# Access Compliance Report

## Public Rights-of-Way

Intersection ID: 10040846	Main Street: WAKEFIELD_DR	Cross Street: N/A	Location: NW
ADA ID: 9C68624A29B9	Ramp Type: BlendTrans1	Initial Pass/Fail: Pass	Overall Compliance: No
Severity Score: 0.25			
Codes/Mitigation Info/Possible Solution		Field Measurements/Component Compliance

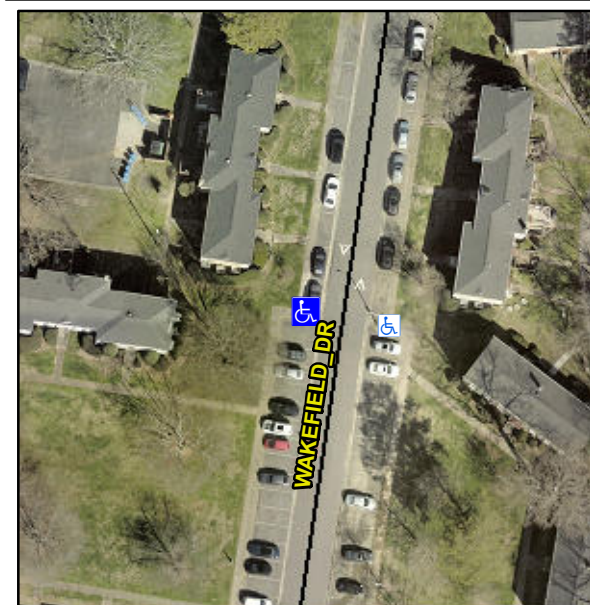
**CROSSES PARKING SPACES**

**R304.5.3, R304.2.2-Perp, R304.3.2-Para, R305.2**

**Remove & Replace Curb Ramp With Two New Directional Ramps or Equivalent.**
